NAVIGATION AND VESSEL INSPECTION CIRCULAR NO. 4-85 CHANGE 2

Subj: Change 2 to NVIC 4-85 of 29 May 1985, Recalls and Other Corrective Measures for Lifesaving and Fire Protection Equipment

NAVIGATION AND VESSEL INSPECTION CIRCULAR NO. 4-85 CHANGE 1

Subj: Recalls and Other Corrective Measures for Lifesaving Equipment

FITZ-WRIGHT SUITS RECALL PROCESS

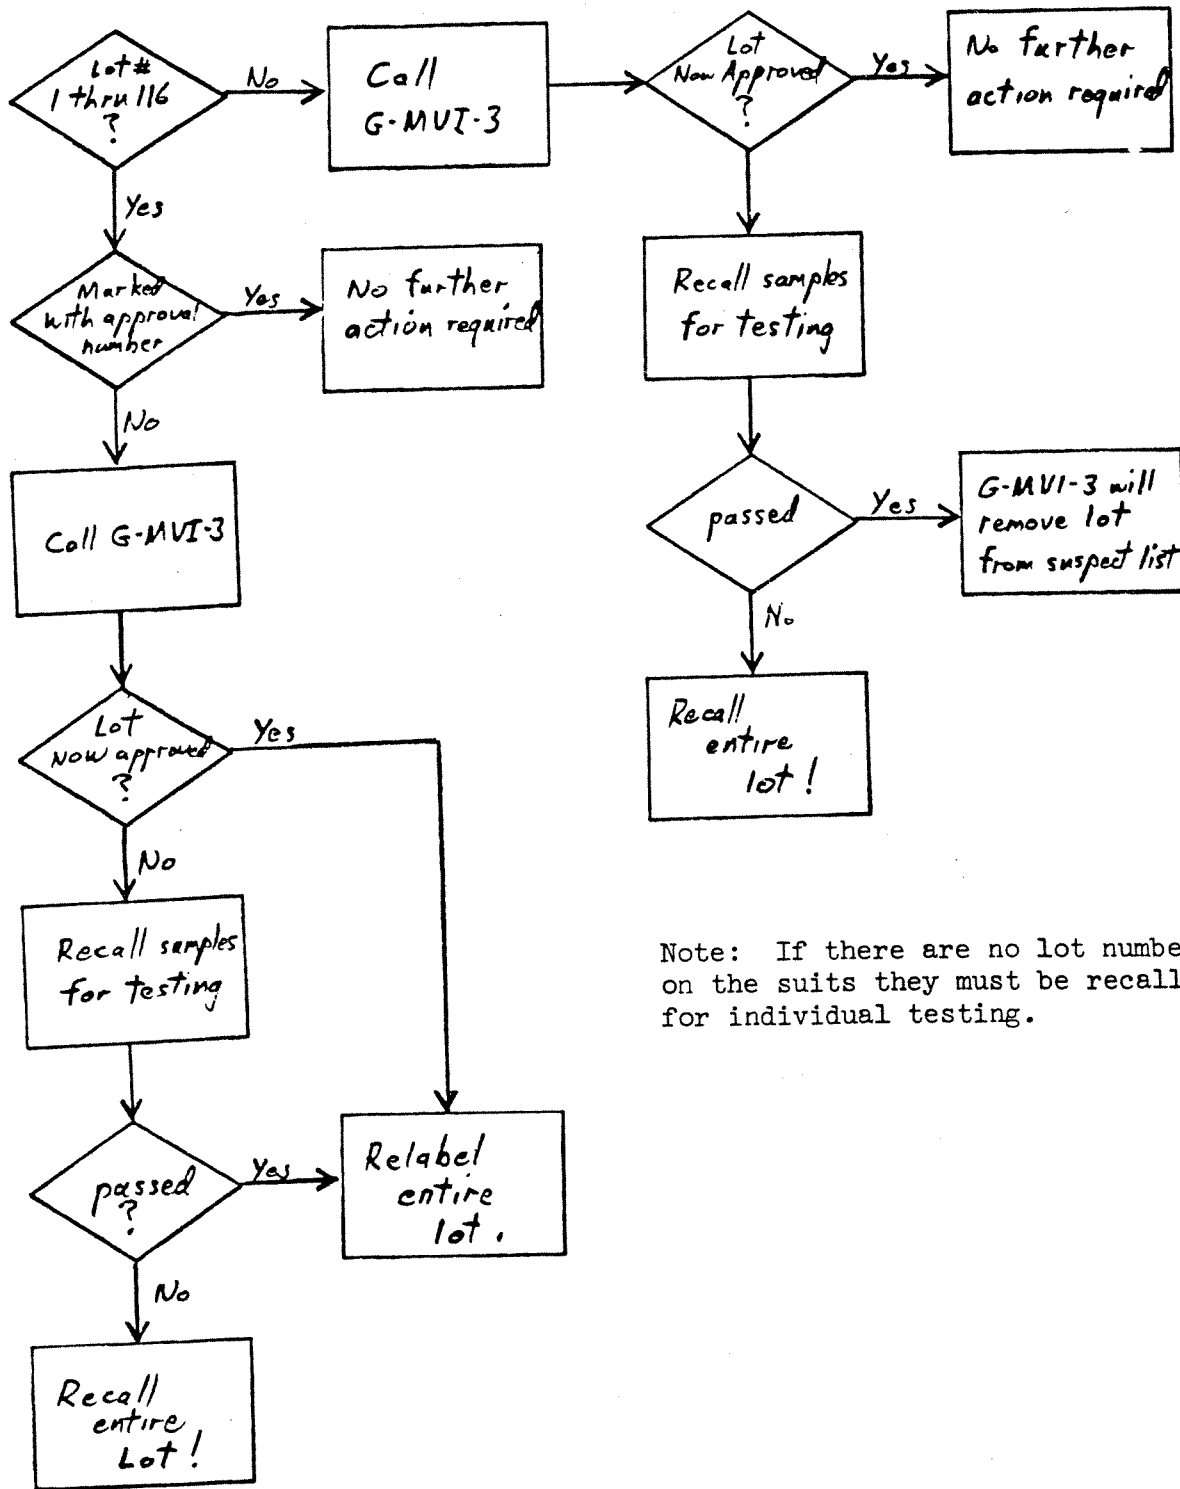
- a. Fitz-Wright exposure suits up to and including Lot 116 were inspected and tested for Coast Guard approval by Warnock Hersey Professional Services but were not marked with an approval number on the suit.
- b. Production inspection has since been taken over by Underwriters Laboratories (UL), but suits from lot numbers 117-132, 134, and 136-137 may have been labeled as Coast Guard approved even though they were not inspected and tested at the factory by Warnock Hersey or UL.
- c. Some Fitz-Wright suits have been found to have no lot numbers, and their factory inspection status can not be determined.

- a. Where records in the custody of Underwriters Laboratories indicate that a lot numbered 116 or lower was inspected by Warnock Hersey Professional Services, the suits may be relabeled in the presence of a UL inspector.
- b. Where the records indicate that any lot was not inspected by an independent laboratory, representative samples of the lot must be returned to Fitz-Wright for testing by a UL inspector. Fitz-Wright will provide replacements for the samples recalled for testing. After samples of a lot have been tested and inspected, the lot will be approved and all suits of that lot may be relabeled in the presence of a UL inspector.
- c. Any suit which does not bear a lot number can not be considered Coast Guard approved.

- a. Coast Guard inspectors should contact Commandant (G-MVI-3) when suspect suits are encountered, giving lot number of suits, approval number if marked, and identity of vessel and operator. Vessel need not be detained. Commandant (G-MVI-3) can be reached on FTS 426-1444.

- b. Operators may contact Underwriters Laboratories to determine the status of suspect suits and arrange for relabeling. If samples from the lot are needed, the operator will be referred to Fitz-Wright to arrange for replacements and shipping of samples. Point of Contact at UL is:

- c. The flow chart on the following page is provided to guide decisions on testing and relabeling.

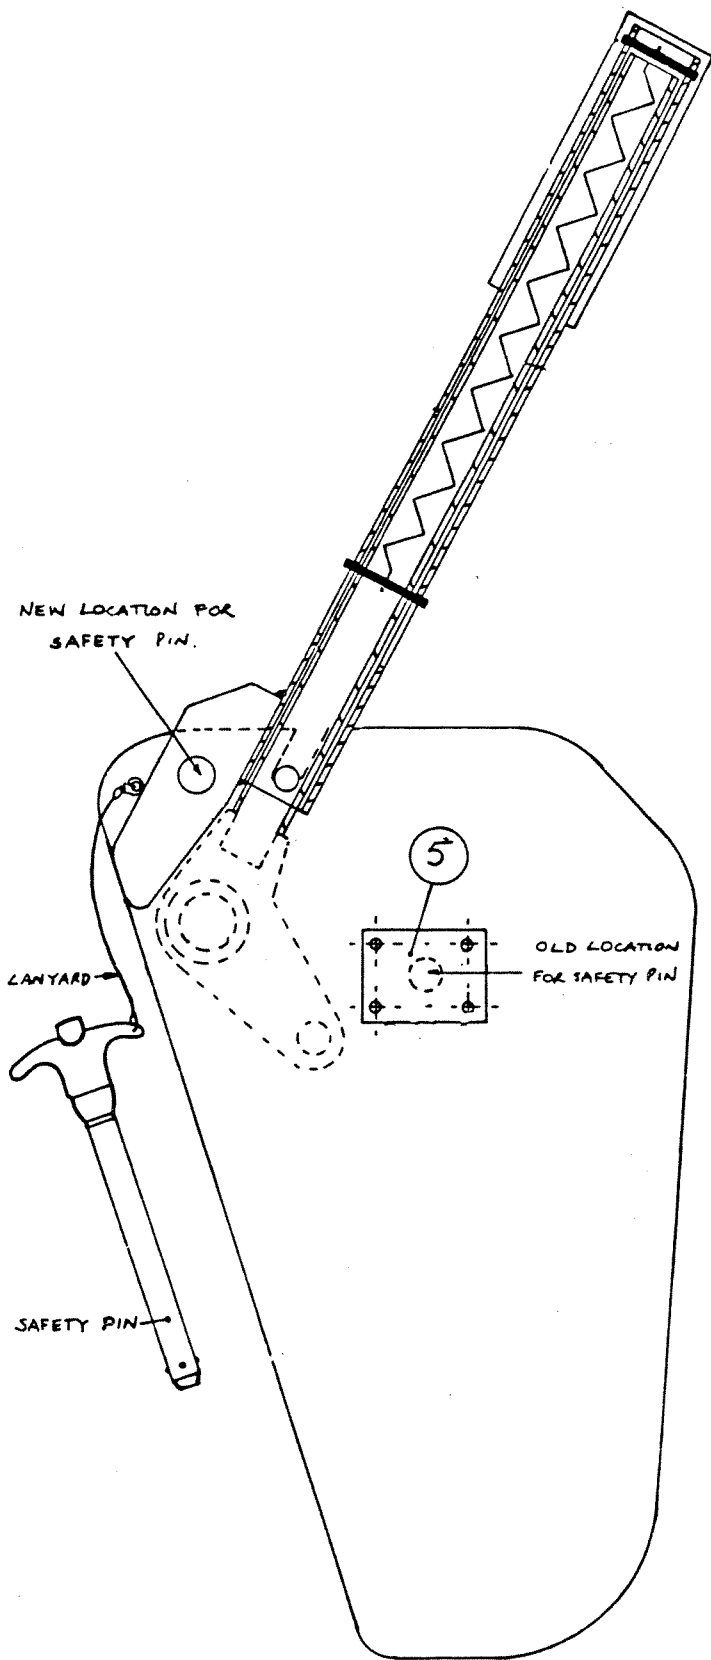
1. PROBLEM. The safety pin on the Titan release gear operating handle used in certain Watercraft America lifeboats, can be inserted before the handle is in the safe, fully closed position. In this condition, the release hooks may appear to be fully closed, but may unexpectedly open when a load is applied.

2. DISCUSSION. Watercraft America, Inc. has developed a modification to prevent the accidental insertion of the safety pin before the handle is in the fully closed position.

- a. Titan release gear with approval number 160.033/69/0 must be modified. Titan gear that has been modified can be identified by the cover plate over the old safety pin hole (item 5 on the drawing on the following page), and by the plate added to the release gear handle to accommodate the new safety pin location (see "NEW LOCATION FOR SAFETY PIN" on the drawing).

3. ACTION.
 - a. Vessel and MODU operators having Watercraft America lifeboats equipped with Titan gear having approval number 160.033/69/0 shall make sure the release gear is modified in accordance with Watercraft America drawing SP-201 and Engineering Instruction P-131, both dated 28 October 1985. The Coast Guard Officer in Charge of Marine Inspection shall be notified before the modification work begins. The drawing and instruction may be obtained from:

ILLUSTRATION 1

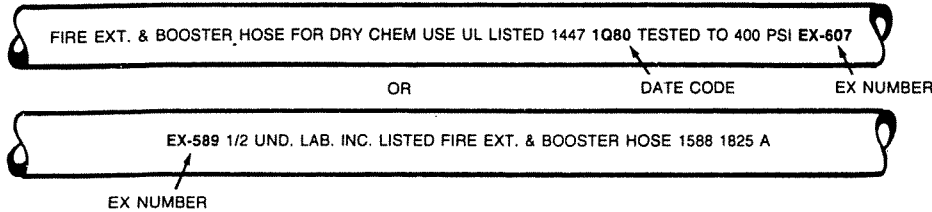
1. PROBLEM: Some hoses on Ansul Red Line fire extinguishers manufactured between 1977 and July 1985 have failed during operation. Couplings on other hoses have separated from the hose.
2. DISCUSSION: Although the failed hoses are relatively small in number, the manufacturer has started a replacement program to eliminate the risk of hose and hose coupling failures.

1. If extinguisher has a yellow "Inspected" sticker on the front, go to step 9.
2. Find U.L. Listing information printed on hose (either white print or molded on hose cover). (See illustration 1 below.)

3. If there is no printing, or printing is unreadable, replace hose assembly and destroy old hose.
4. Refer to **EX** number on hose, if it is **NOT** EX-607 or EX-589, hose is good, do **NOT** replace.
5. If EX-607

ILLUSTRATION 3

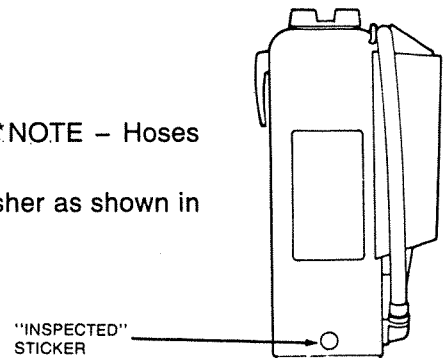
9. Perform recommended inspection and maintenance on **ALL** extinguishers. *NOTE - Hoses not included in this program may need replacement due to normal wear.
10. When all work is completed, place yellow "Inspected" sticker on extinguisher as shown in illustration 3.

Figure 1 of Enclosure(22) to NVIC 4-85 CH-2

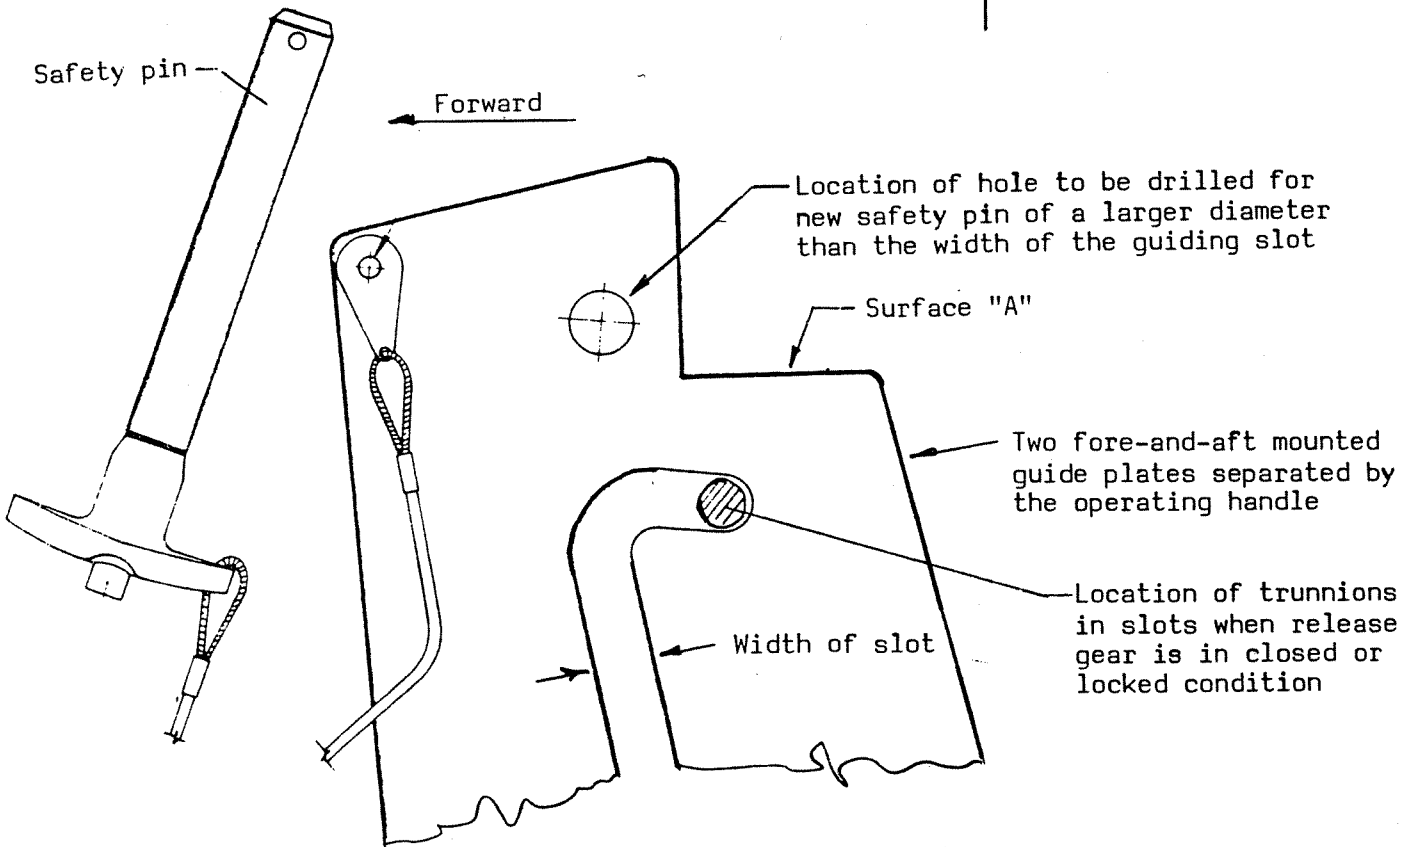
1. PROBLEM. The safety pin for the Viking release gear operating handle used in certain Watercraft America lifeboats, can be accidentally inserted into the slot for the release handle trunnion, rather than the hole intended for the safety pin. If this is done, the release gear is not in a safe condition.

2. DISCUSSION. Watercraft America, Inc. has developed a modification to prevent the accidental insertion of the safety pin before the handle is in the fully closed position. Viking release gear with approval numbers 160.033/66/0, 160.033/66/1, and 160.033/66/2 must be modified by drilling out the safety pin hole and replacing the original safety pin with a larger one.

3. ACTION.
 - a. Vessel and MODU operators having Watercraft America lifeboats equipped with Viking gear having approval numbers 160.033/66/0, 160.033/66/1, or 160.033/66/2 shall make sure the release gear is modified in accordance with Watercraft America drawing SP204 dated May 2, 1986. The Coast Guard Officer in Charge of Marine Inspection shall be notified before the modification work begins. The drawing and instruction may be obtained from:

Watercraft America, Inc.
P.O. Box 1130
Edgewater, FL 32032
(904) 428-5781
Telex: 567415
 - b. Coast Guard inspectors will require modification of Watercraft America Viking release gear with approval numbers 160.033/66/0, 160.033/66/1, or 160.033/66/2 in accordance with the Watercraft America drawing and instruction.

Figure 1 of Enclosure(23) to NVIC 4-85 CH-2

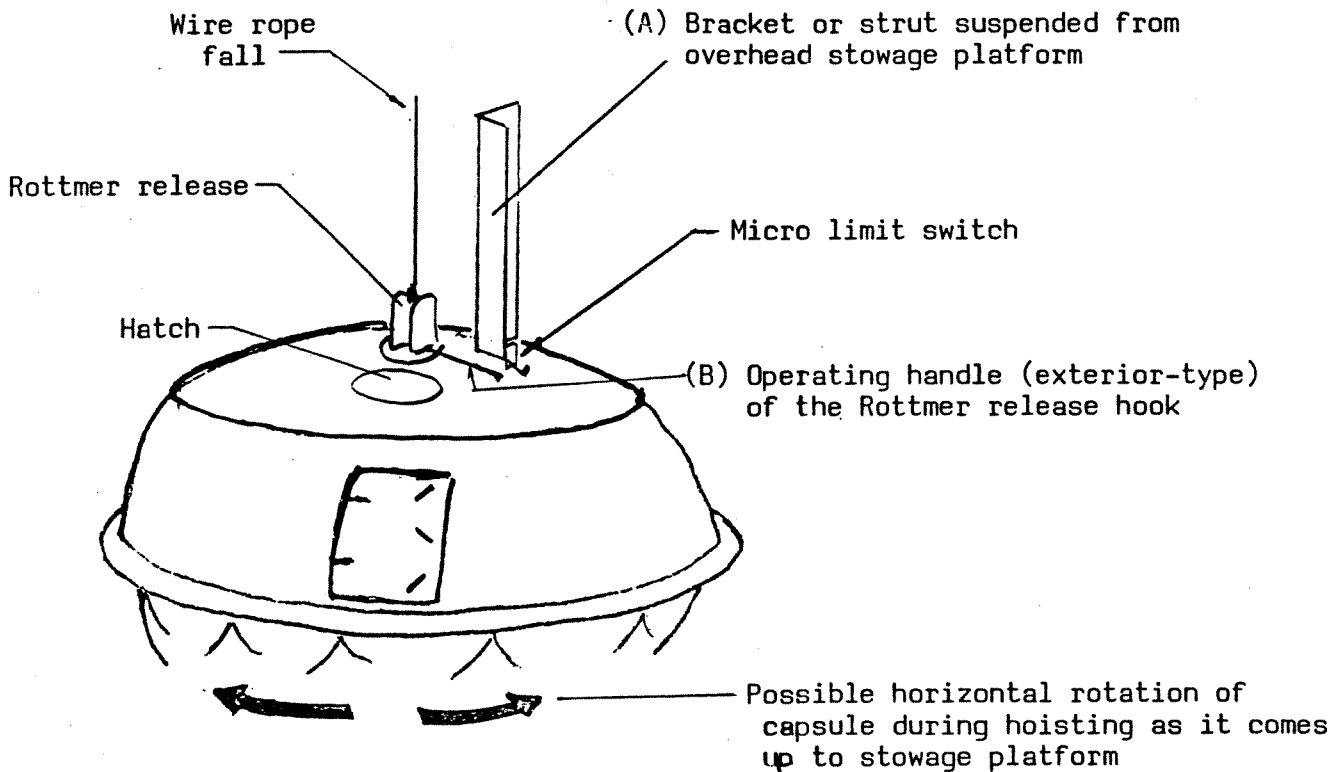
1. PROBLEM: Some launching devices for Whittaker Survival capsules may have been modified by the unauthorized addition of brackets to hold microswitches or other devices added by the owner or operator.

2. DISCUSSION: The unauthorized modifications may appear to be almost identical to the brackets that hold the limit switches which are part of the approved launching system. If brackets are added and not carefully located, they can engage the cable and sector operating mechanism on those capsules equipped with Rottmer type hooks. This has happened on two separate occasions, resulting in the accidental opening of the hook and dropping of the capsule. Any person on board the capsule is at risk of being seriously injured.

NOTE: The above arrangement has the danger of letting the operating handle(B) of the Rottmer release to push against the bracket(A) suspended from under the stowage platform. This could result from the horizontal rotation of the capsule as it comes up into the stowed position. This unintended interference is a potential hazard because of the chance that the operating handle(B) could be moved from its locked position, thus permitting the capsule to drop free of the wire rope fall.

3. ACTION: Servicing personnel and Coast Guard inspectors should make sure that any brackets on Whittaker capsule launching devices are part of the approved system or are approved modifications. Generally, the only brackets coming close to the surface of the capsule should be those holding the limit switches which prevent the capsule from being winched into the stops under motor power. Any others should be considered suspect, unless the owner or operator can show that they are approved additions. Any unauthorized modifications of this type must be removed. Questions on whether or not such brackets are approved can be answered by the manufacturer:
